Urgent Product Correction Notice

This is a follow-up to the previously issued Urgent Product Correction Notice regarding compromised VITEK® 2 card pouches. In regards to the VITEK® 2 Identification / Antimicrobial Susceptibility Test Cards referenced in the previous Urgent Product Correction Notice, three (3) additional card lots have been identified.

Figure B - New Stitch Seal

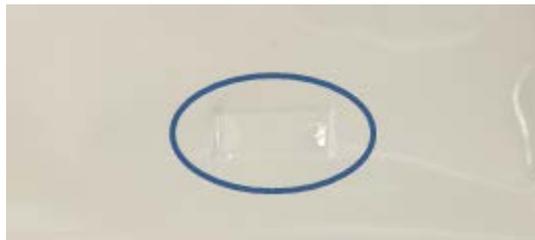
The root cause of this issue has been identified and corrective measures have been taken to ensure issues of this type do not affect future Manufacturing lots. Card lots manufactured after March 16, 2017 include a new stitch seal (see Figure B below) and are not affected by the described issue.
